ORPHAN STORE
MOOR LANE, CLITHEROE

PROPOSED ELEVATIONS

DISCIPLINE: ARCH JOB NO: 2006-228 DRAWING NO: P04

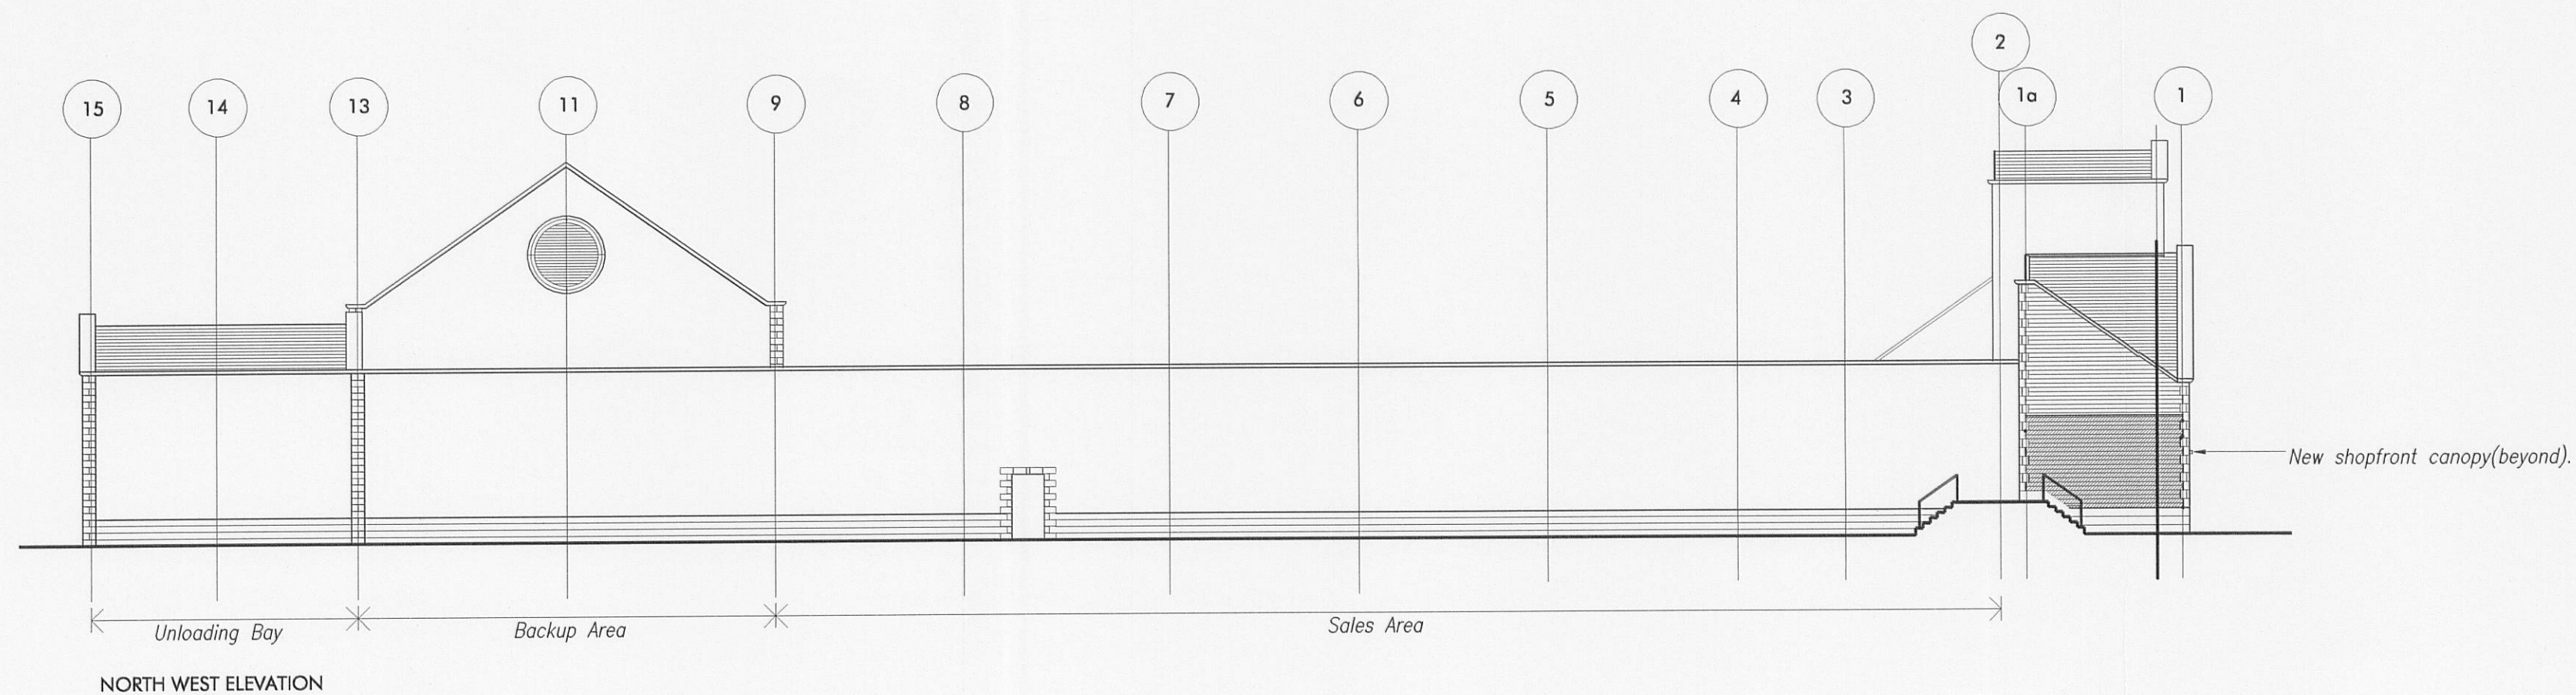
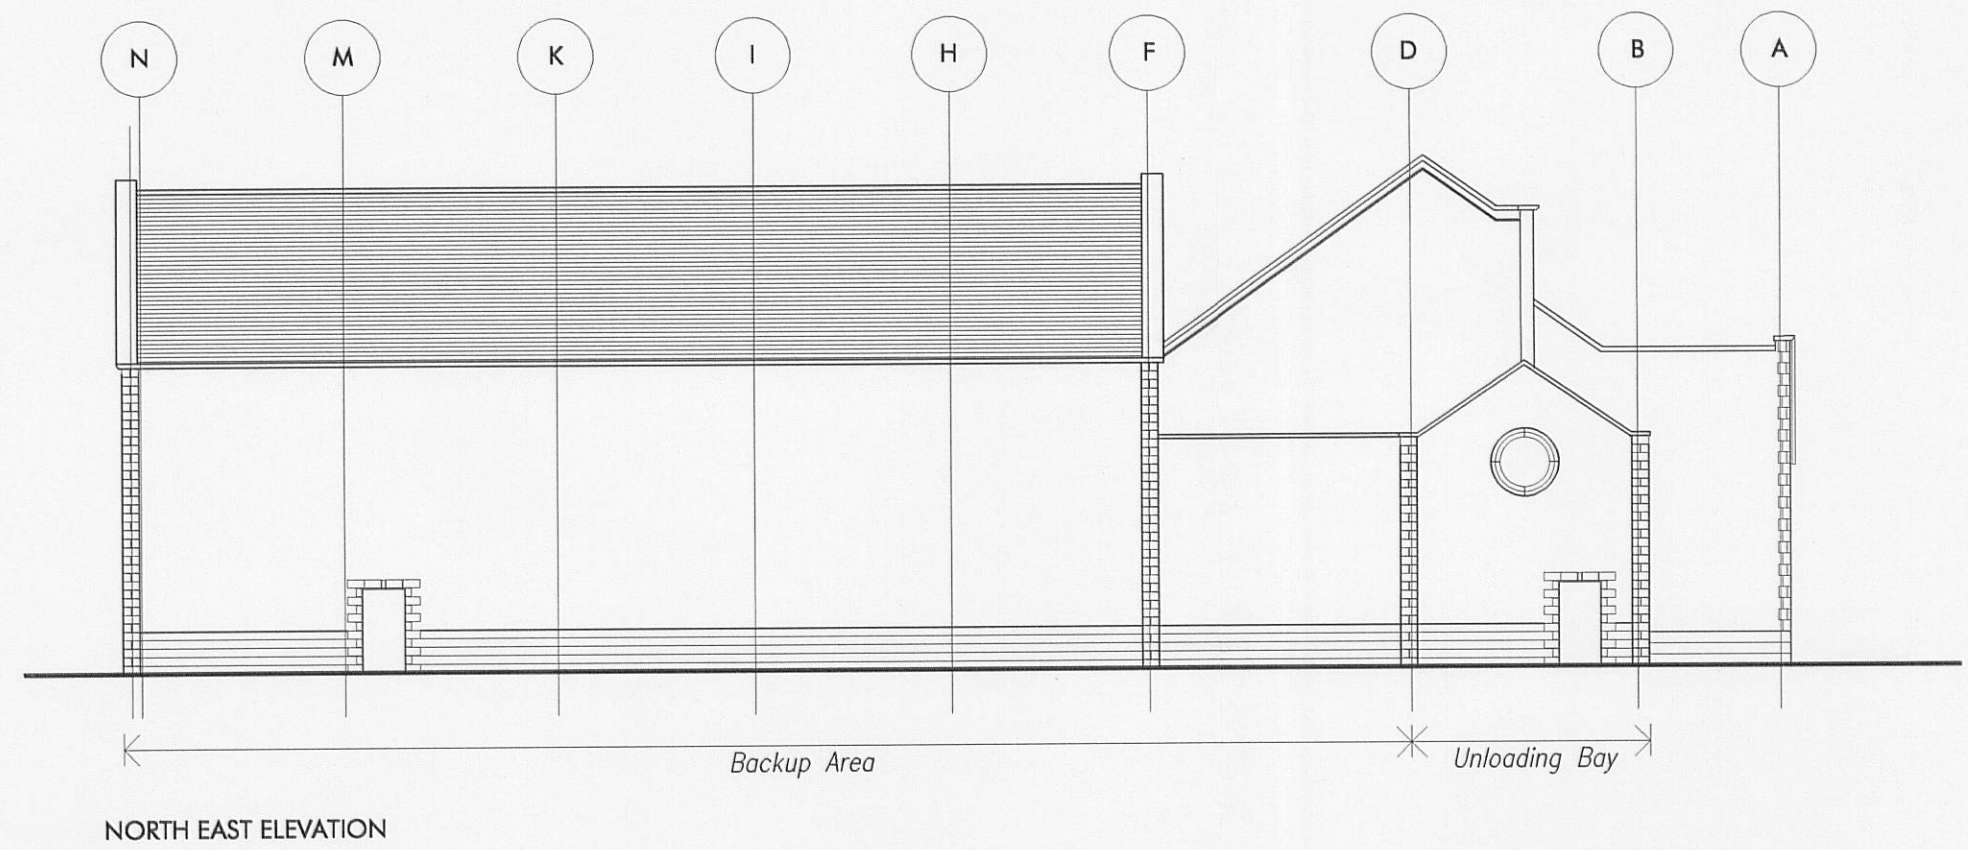
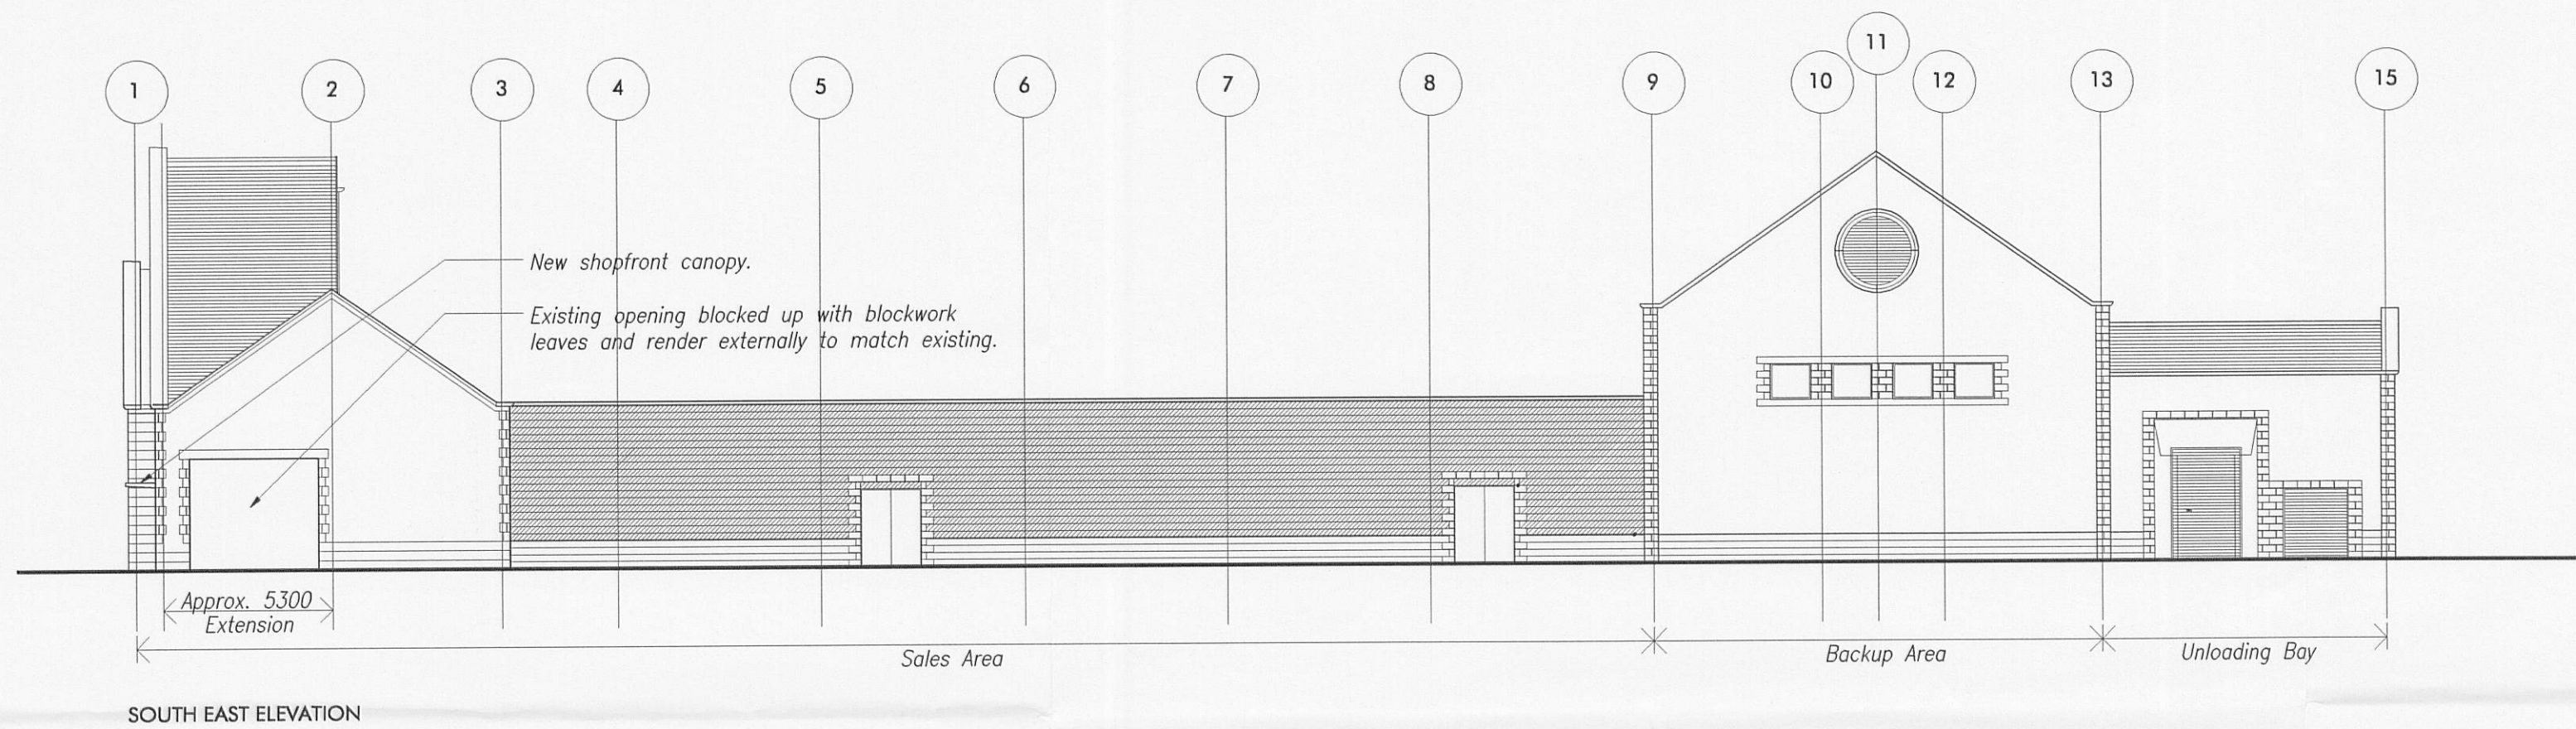
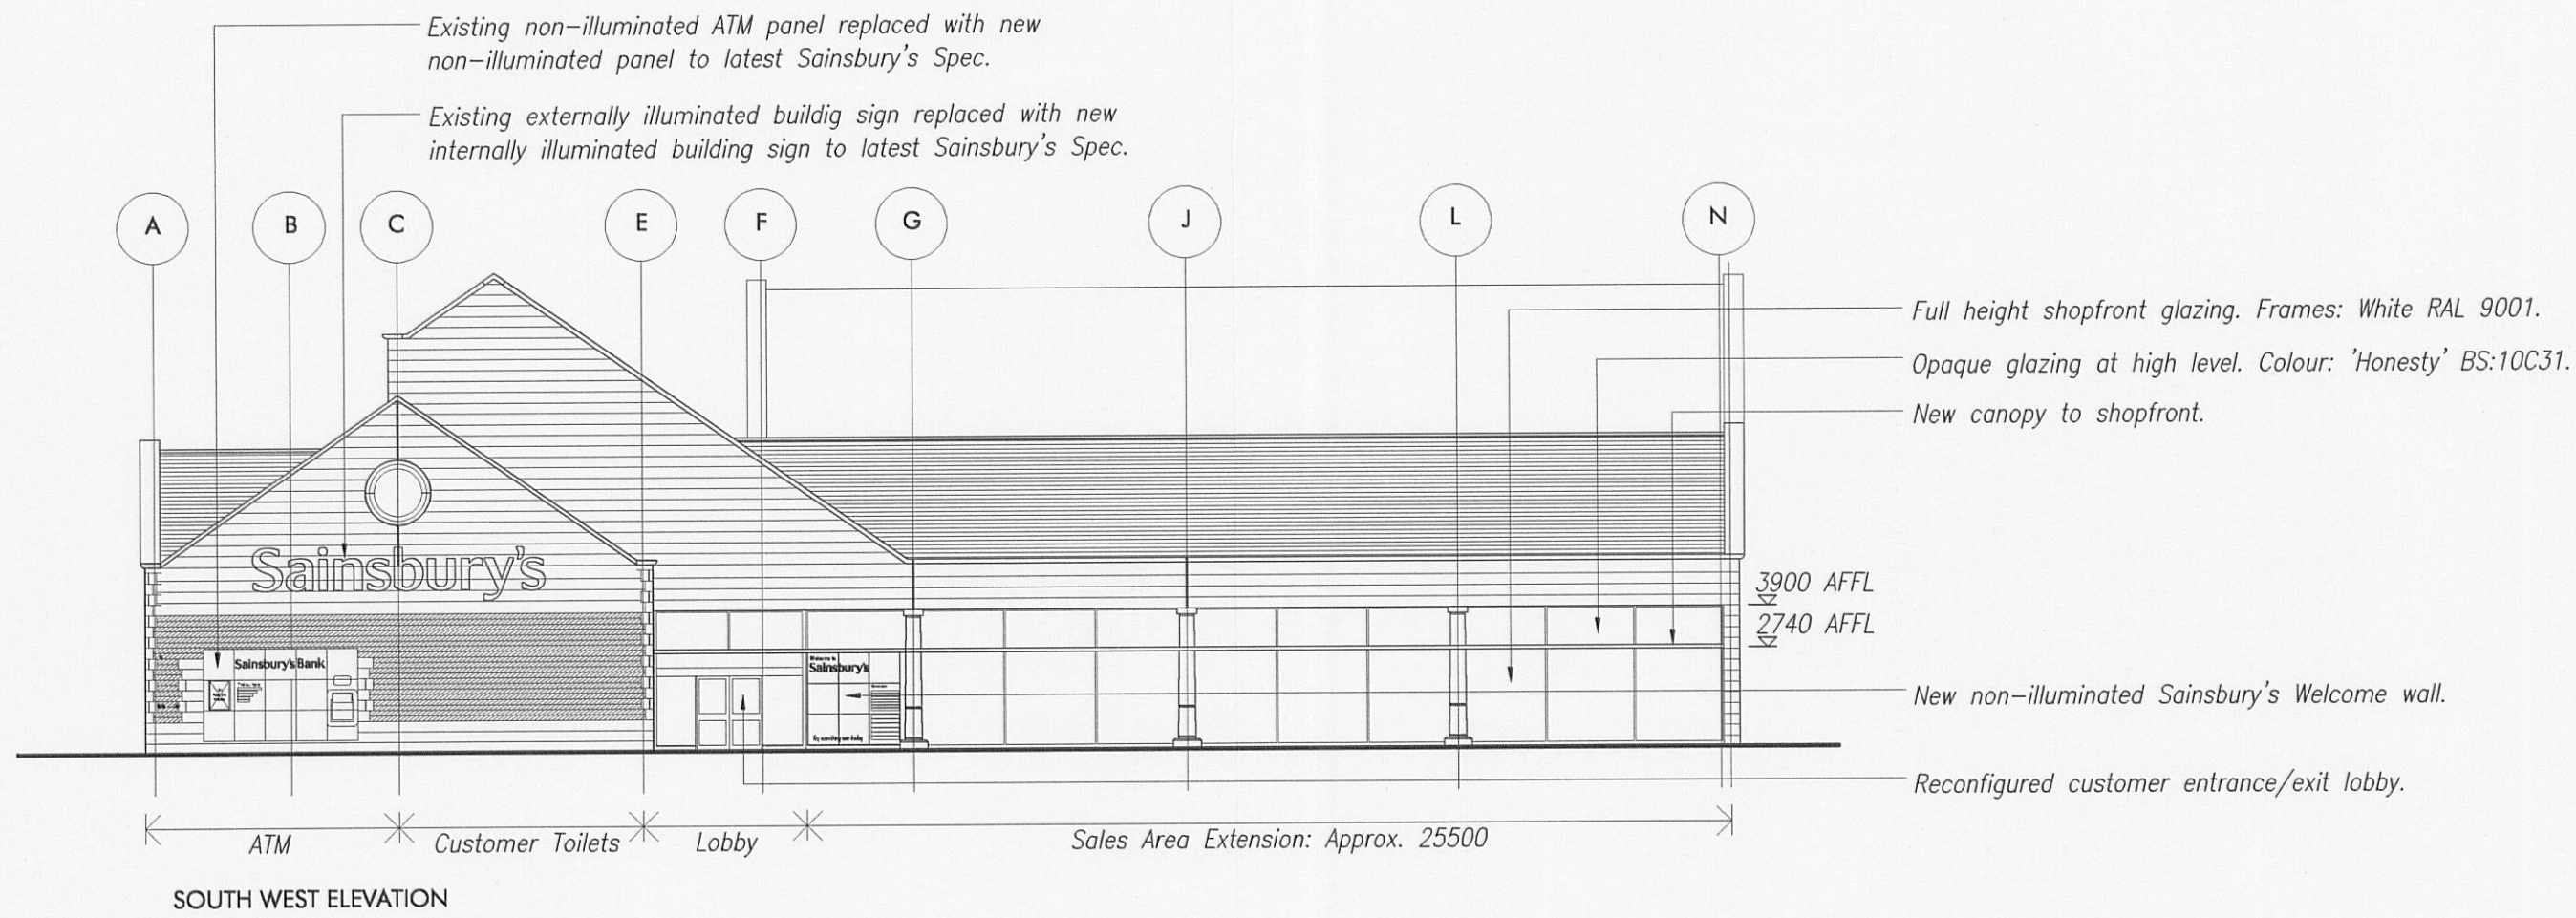
Updated to accommodate planner's comments: height of eaves to South west elevation added, dimensions of sales area extension added.
